**TOWN OF WINTER PARK
PLANNING COMMISSION
Tuesday, August 27, 2024 8:00 AM**

- a) PUBLIC HEARING: Preliminary Plat – The Landings Townhomes – Lot 2, Cullen Minor Plat – 185 Vasquez Road (PLN24-005)
- b) PUBLIC HEARING: Major Site Plan – The Landings Townhomes – Lot 2, Cullen Minor Plat – 185 Vasquez Road (PLN23-095)

TO	Planning Commission
FROM	Shelia Booth, AICP, CPS Contracted Planner
THROUGH	James Shockey, AICP, Community Development Director
DATE	August 27, 2024
RE	PUBLIC HEARING: Major Site Plan (MSP) and Preliminary Plat (PP) – 185 Vasquez Road/The Landing (PLN23-095 and PLN24-005)

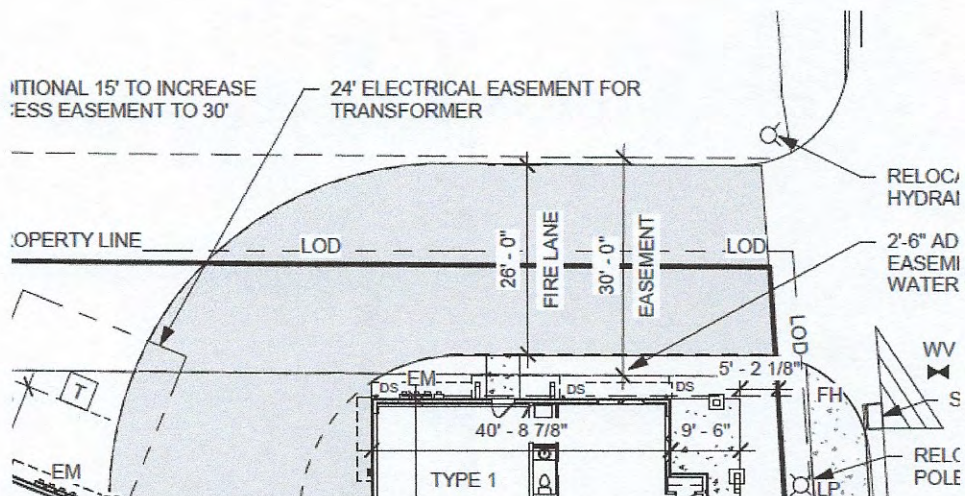
1. **Inaccuracies in the Traffic Study:** The traffic study of past usage contains several false assumptions. It claims that the existing seven units (four units in the larger house, and three units in the triplex) generate an average of "54 Daily Trips," implying that each *existing* unit used the driveway 6-7 times per day.

Please note, over the past twenty years, most of these very small units were occupied by a single person. (Average occupancy verified by the previous property owners.) So this study, stating each existing unit would use the driveway 6-7 times per day, must be incorrect. More reasonably, a complex of 7 units, with one tenant in each, would actually generate, at MOST, 21-28 total movements daily, which is on average 3-4 times a day for each unit. (Again, we're being generous. This would actually be a high average of usage for the past twenty years. Most people do not come and go 6-7 times a day up here in Grand County.)

The more recent study, based on 19 units, apparently used the same inaccurate average from above, and estimates approximately "138 Average Daily Trips." This suggests that each new unit would use the driveway an average of 7.26 times per day, which is similar

to the earlier, inaccurate calculation. And, please note, this estimate does not consider that the newer, larger units could easily house **multiple** drivers per unit, significantly increasing driveway usage.

Landings Townhomes Proposed Plat

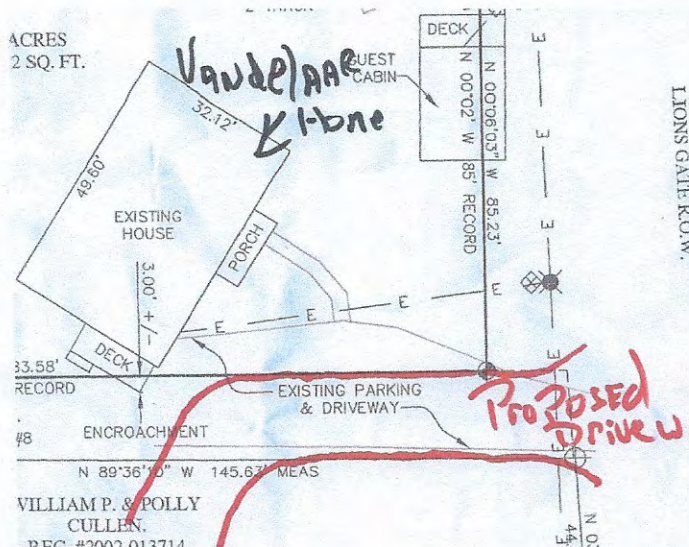
Although a 15-foot easement was recorded in 1941 for a possible roadway into the property, the Town of Winter Park now owns the easement. We believe that the new development should not use this easement to meet its own requirements. If the Town of Winter Park permits this, it effectively gives the shared property's use to someone else, at a massively unbalanced benefit.

As quoted by Norm Larkins, a highly respected Real Estate Attorney here in Grand County, the easement should be vacated and returned to the original owners, per the following legal precedent:

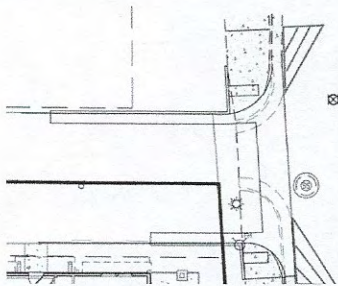
3. **Relocation of Fire Hydrant:** The existing fire hydrant is in front of the developer's property, but the proposal seeks to move it in front of our property, which we strongly oppose.

4. **Curb-** They propose a 6" curb along my property which interferes with my ability to park a vehicle.
